Access Compliance Report

Public Rights-of-Way

(Curb Ramps)

Intersection ID: 10040928	Main Street: WALLACE_RD	Cross Street: N/A	Location: SE
ADA ID: 08710ADB39DB	Ramp Type: PerpDiag	Initial Pass/Fail: Fail	Overall Compliance: No
Codes/Mitigation Info/Possible Solution		Field Measurements/Component Compliance	
Severity Score: 31.25

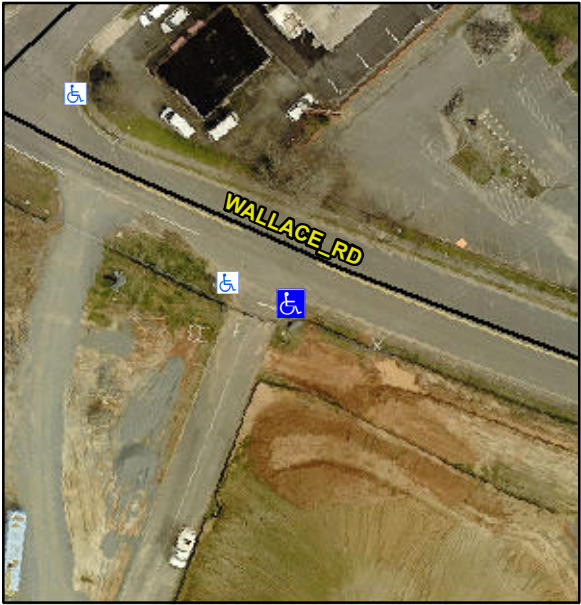
Possible Solutions:	Compliance	Description	Data	Compliance	Description	Data
	Remove & Replace Curb Ramp With Two New Directional Ramps or Equivalent.	N/A	Ramp Length (in)	48.0	No	Ramp Slope (%)	11.7
		No	Ramp Width (in)	35.0	No	Ramp XSlope (%)	4.0
		N/A	Flare Type LT	N/A	N/A	Flare Type RT	N/A
		N/A	Flare Slope LT (%)	N/A	N/A	Flare Slope RT (%)	N/A
		N/A	Flare Traversable LT?	N/A	N/A	Flare Traversable RT?	N/A
		N/A	Landing Length (in)	N/A	N/A	DWS Provided?	N/A
		N/A	Landing Width (in)	N/A	N/A	DWS Contrast?	N/A
		N/A	Landing Slope (%)	N/A	N/A	DWS Length (in)	N/A
		N/A	Landing X Slope (%)	N/A	N/A	DWS Full Width?	N/A
		N/A	Landing Curb? (Y/N)	N/A	N/A	DWS Offset (in)	N/A
		N/A	Shared Landing?	N/A			
		N/A	Gutter Ponding?	N/A	N/A	Gutter Slope (%)	N/A
		N/A	Gutter Lip Ht (in)	N/A	N/A	Gutter X Slope (%)	N/A
		N/A	Painted X Walk1?	No	N/A	Painted X Walk2?	No
			X Walk 1 Direction	To N		X Walk 2 Direction	To W
		N/A	X Walk 1 Width (in)	N/A	N/A	X Walk 2 Width (in)	N/A

X Walk 1 Slope (%)	4.0		X Walk 2 Slope (%)	3.9
			X Walk 1 X Slope (%)	4.4		X Walk 2 X Slope (%)	0.5
		N/A	Ramp inside XWalk1?	N/A	N/A	Ramp inside XWalk2?	N/A
<p>Surveyor Notes:</p> <p>N/A</p> <p>PROW/ADA:</p> <p>Not Found, R304.5.1, R304.2.2, R304.5.3</p>			Road Slope (%)	2.6	N/A	Clear Space?	N/A
			Road X Slope (%)	2.9	N/A	Clear Space to XWalk (in)	N/A
		N/A	Any Obstructions?	N/A	N/A	Storm Grate/Utility Hazard?	N/A
			Obstruction Type			Storm Grate/Utility Type	
					N/A		N/A
					Yes	Surface Condition? (G/P)	Good
